SERVICE BULLETIN

No. 441

Piper Aircraft Corporation

Subject: Clamping of Manifold Pressure Hose

INSTRUCTIONS

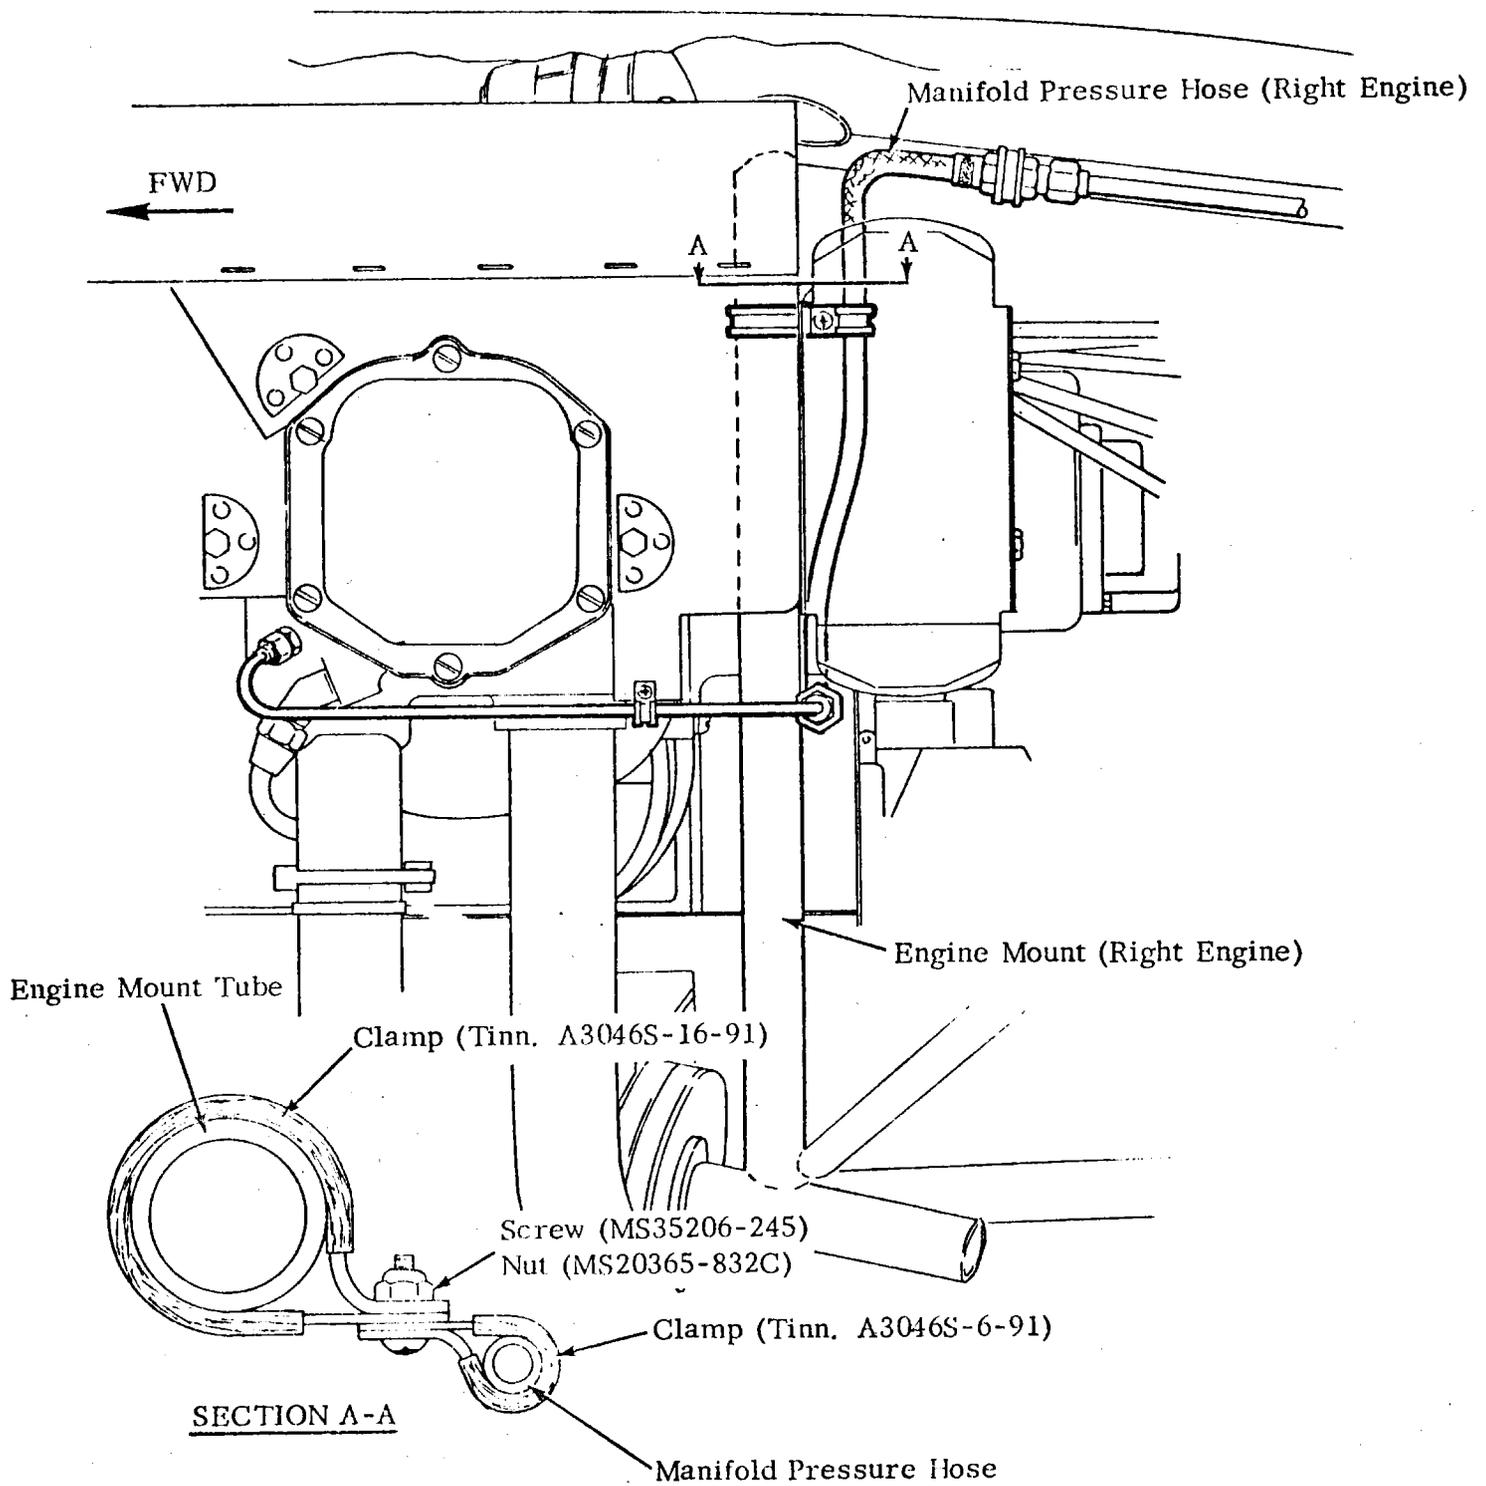
Locate and install clamps to right engine manifold pressure hose and engine mount tube as shown above. Locate clamps to insure sufficient clearance between the manifold pressure hose and engine mount tube and between the hose and magneto.
